DEVELOPMENT REVIEW APPLICATION

ROSEMONT RIDGE MIDDLE SCHOOL

Class II Design Review

Subject: Response to City of West Linn lighting questions

ILLUMINATION SUMMARY

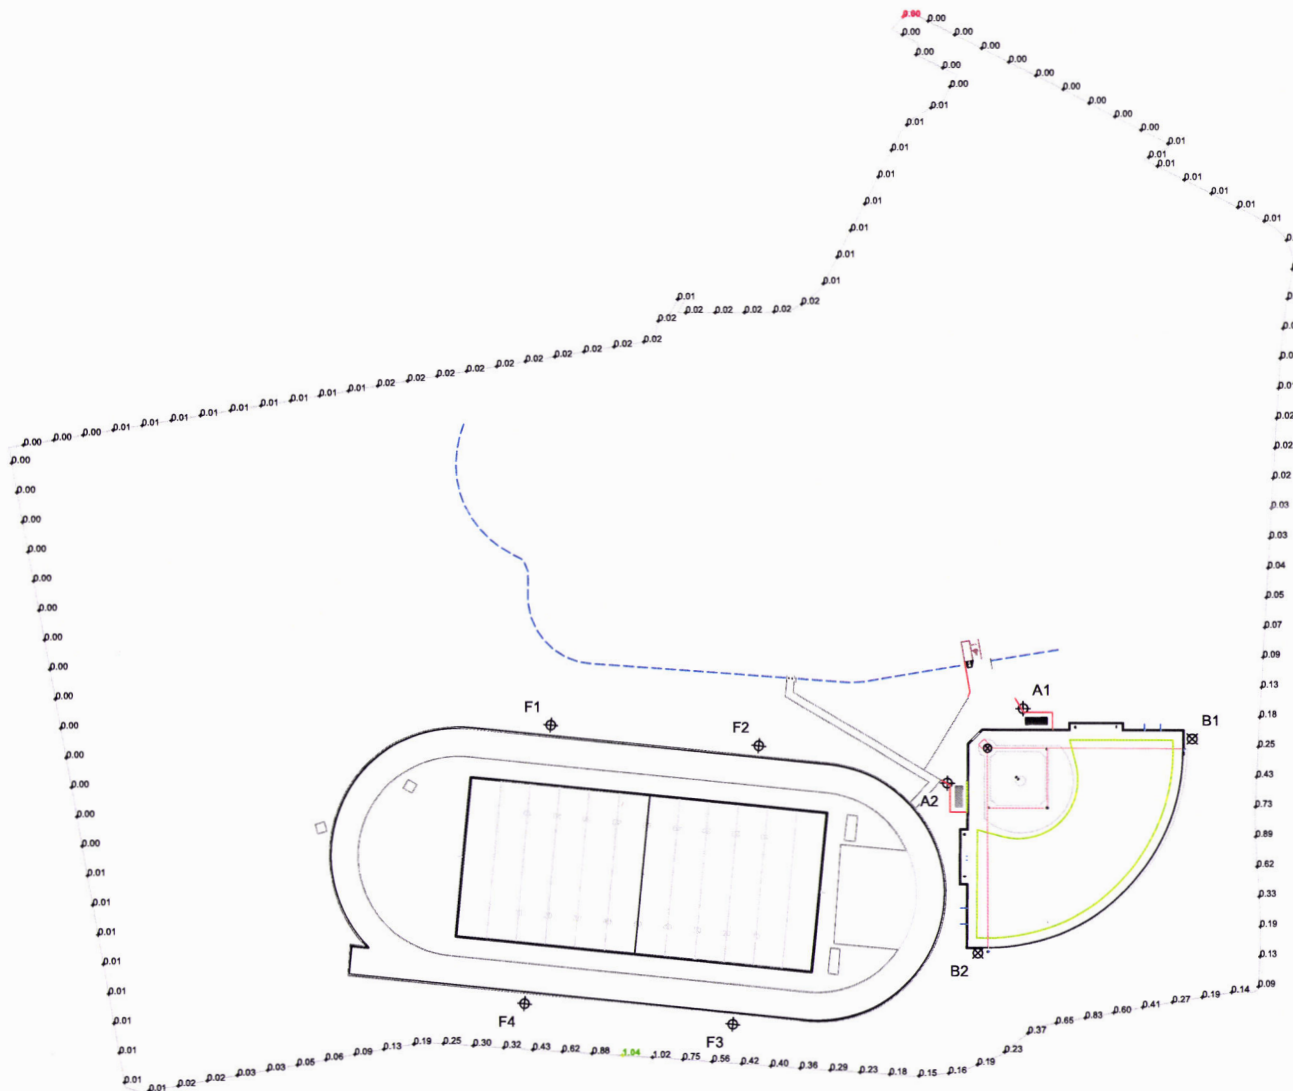
1. What do these luminaire numbers (e.g. .05) mean in lay terms?
2. What will the luminaire numbers be at the edge or perimeter of the site?
(There are numbers shown ranging from 0 feet to about 100 feet from athletic fields which is not the perimeter.)
3. Will the pylon lighting point towards the homes at 1156 Rosemont and 21895 Salamo Road?

2. Refer to attached lighting calculations for lighting levels at the site property line, in most cases the lighting levels are fractional amounts of a footcandle.

3. One of the four softball field light poles has fixtures facing the direction of Salamo road. The lights on top of the pole however are pointed down at the playing field and have cutoff shields to prevent excess lighting beyond the field. Calculations at the 150 foot mark from the field show only fractional amounts of a footcandle at that point, which will probably not be noticeable since there is street lighting along the roadway.

The football field has two of the four light poles facing the direction of Rosemont road. The calculation show that very little light is extending past 150 foot from the lights. These also are pointed down at the playing field and have cutoff shields to prevent excess lighting beyond the field.
